CITY PLANNING COMMISSION

PROPOSAL: The applicant is requesting the necessary entitlements to develop 18 corner lots with 36 halfplex units.

APPLC. NO. P82-118

MEETING DATE June 10, 1982

TENTATIVE MAP FOR THE
 RESUBDIVISION OF LOTS 1, 11, 17, 15, 25, 27, 33, 117, 118, 142, 145, 149,
 156, 161, 165, 180, 191 & 193

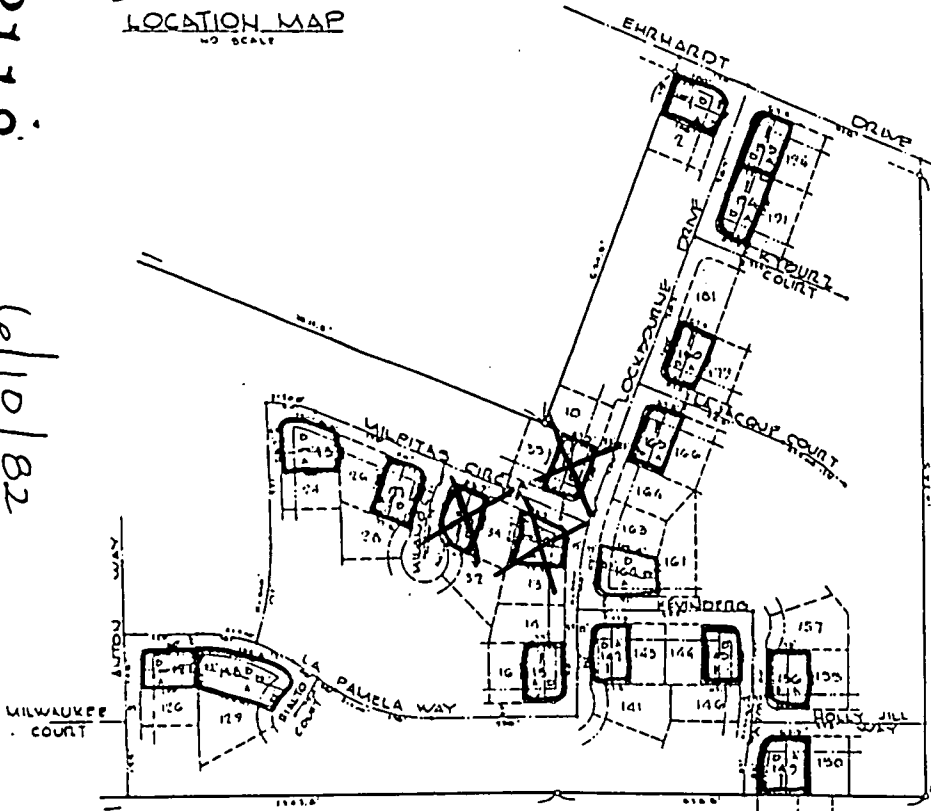
1. Place the following note on the final map: Separate water and sewer service connections must be paid for and installed at the time of obtaining building permits;
2. If there are any existing assessments, file the necessary segregation requests and fees to segregate existing assessments;
3. Pursuant to City Code, Section 40.1302 (Parkland Dedication), the applicant shall submit to the City an appraisal of the property to be subdivided and pay the required parkland dedication in-lieu fees. The appraisal shall be dated not more than 90 days prior to the filing of the final map;
4. Sewer line shall be extended to Lot 11A.

- a. Applicant shall place the following note on the final map: The units shall be built to the new State Residential Energy Conservation Building Standards scheduled to become effective in July 1982, whether or not said standards then become effective.
- b. If there are any existing assessments, file the necessary segregation requests and fees to segregate existing assessments.
- c. Pursuant to City Code, Section 40.1302 (Parkland Dedication), the applicant shall submit to the City an appraisal of the property to be subdivided and pay the required parkland dedication in-lieu fees. The appraisal shall be dated not more than 90 days prior to the filing of the final map.
- d. Sewer line shall be extended to Lot 11A.

EXHIBIT B
OUTSIDE ELEVATIONS

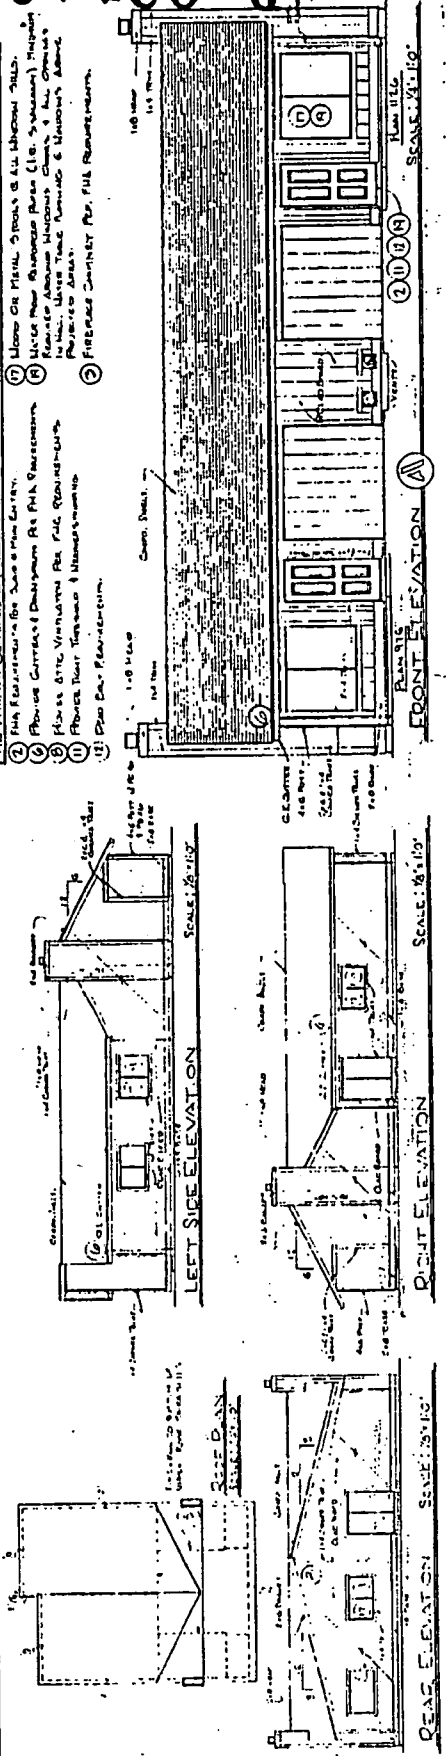
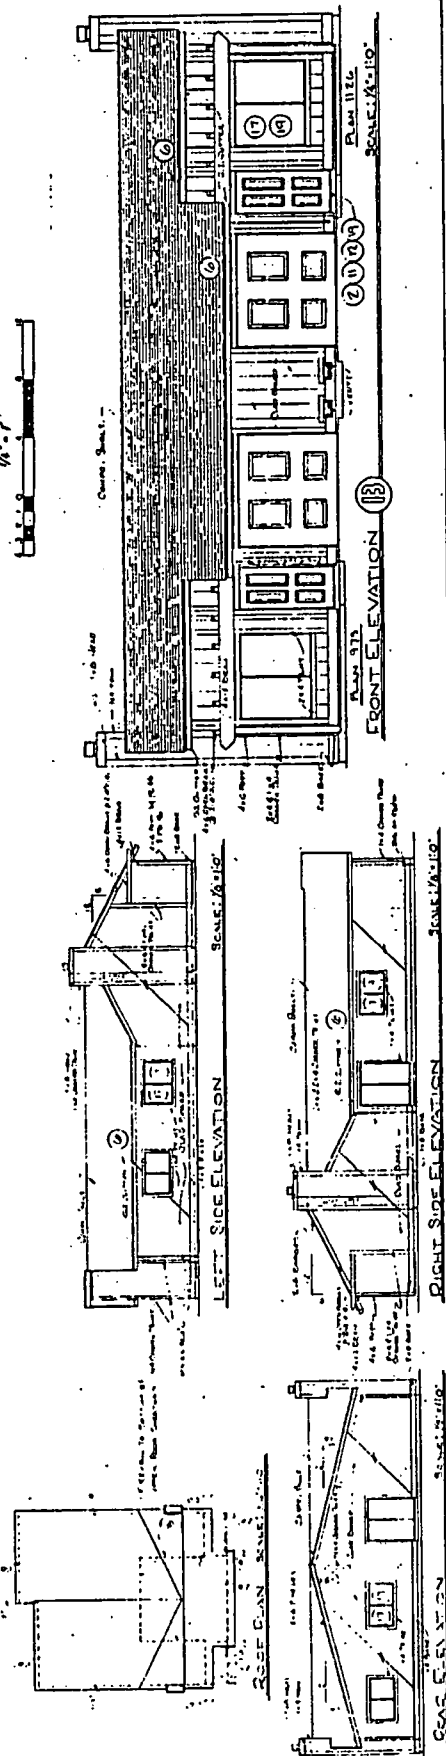
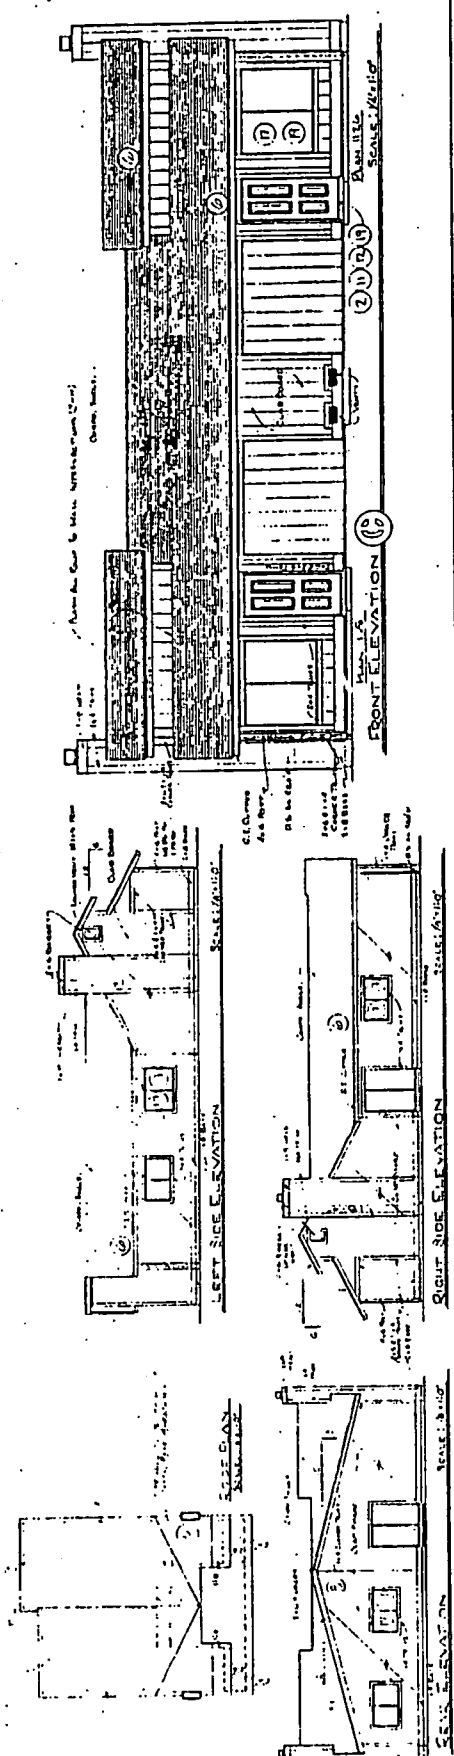
3. The applicant is proposing two and three-bedroom units with single car garages. Four outside elevations are proposed. Staff suggests, for additional variety and visual interest, that Unit A, Plan 1126,975, be designed with a hip roof treatment. Further, pillars at the front outside corners of Plan 1126,975 should be a variety of materials such as brick or rock. Finally, a decorative garage door treatment on the order of Unit B should be applied to Unit A of the same plan. These modifications can be reviewed and approved by the Planning Director at the time building permits are approved.

- a. Plan 1126,975, Unit A, shall be redesigned with a hip roof treatment, and the garage fronts shall have a decorative design applied.
- b. *Affordability* Front pillars for Plan 1126,975 shall be of a variety of materials such as wood, brick and rock.
- c. Applicant shall redesign the structures to provide a garage fronting on each street.
- d. Design of these modifications shall be reviewed and approved by the Planning Director prior to issuance of building permits.
